September 2018 | Response to Comments

CHINO HIGH SCHOOL RECONSTRUCTION

Chino Valley Unified School District

This document includes a compilation of the public comments received on the Chino High School Reconstruction Mitigated Negative Declaration and supporting Initial Study (collectively, “MND”; State Clearinghouse No. 2018081057) and Chino Valley Unified School District’s (District) responses to the comments.

Jefferson Ave/10th Street
Figure 4C-3. Warrant 3, Peak Hour

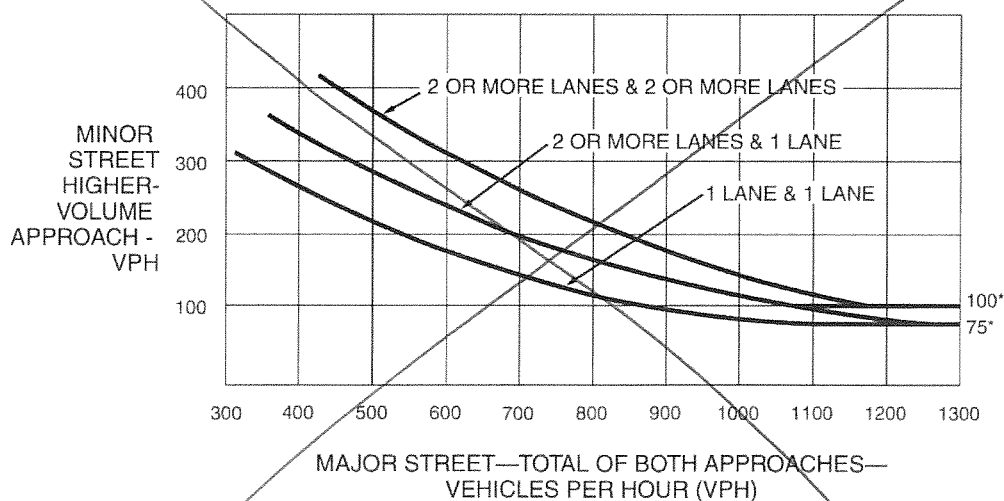
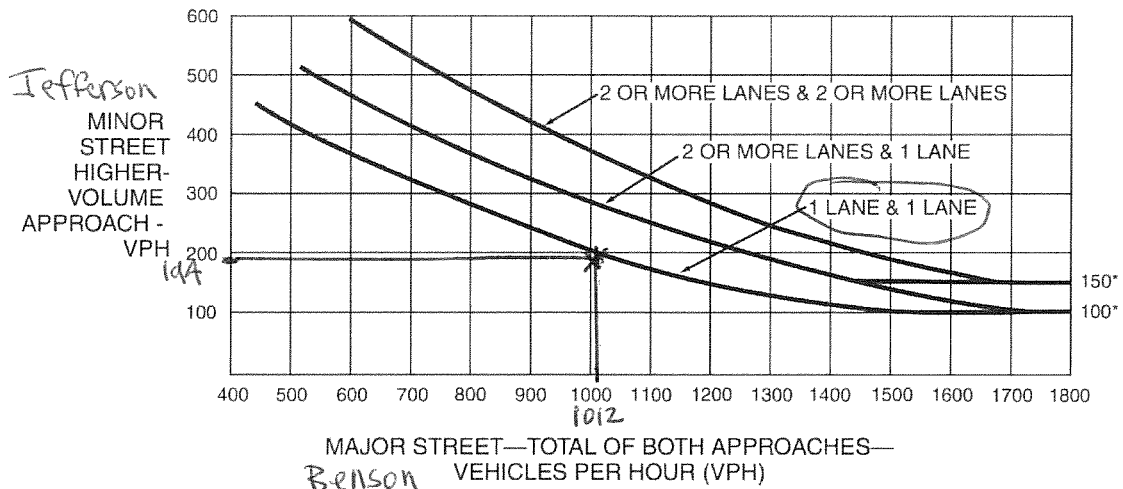
- d. The accumulative effects of items a, b and c will likely change the outcome of the LOS analysis and the warrant studies requested in item e.
- e. Traffic signal/ Stop sign warrants – no analysis sheets were provided or information provided in the MND for all analysis conditions (Existing, Opening Year (2024) and Long Range (2040)). These need to be reviewed, since the traffic pattern/circulation will be different. Chino Police Department is particularly interested in studies for Tenth St/Jefferson Ave and Benson Ave/Jefferson Ave intersections.

- d. Items Comments a, b, and c above have been addressed and will not change the outcome of the LOS analysis and warrant studies.
- e. A traffic signal warrant analysis was conducted for the three intersections at the corners of the school site that are not currently signalized: 10th Street/Jefferson Avenue, 10th Street/Park Place, and Benson Avenue/Jefferson Avenue. The analysis was based on the projected traffic volumes for the year 2024. As shown on the Traffic Calculation Worksheets (Attachment B), the peak hour traffic volumes are below the threshold levels that would justify the installation of a traffic signal. As the existing traffic volumes are lower than the projected 2024 traffic volumes, it was unnecessary to also conduct an analysis for the existing scenario. As traffic forecasts are not available for the year 2040 (see response to Comment c above), an analysis of that scenario was not conducted.
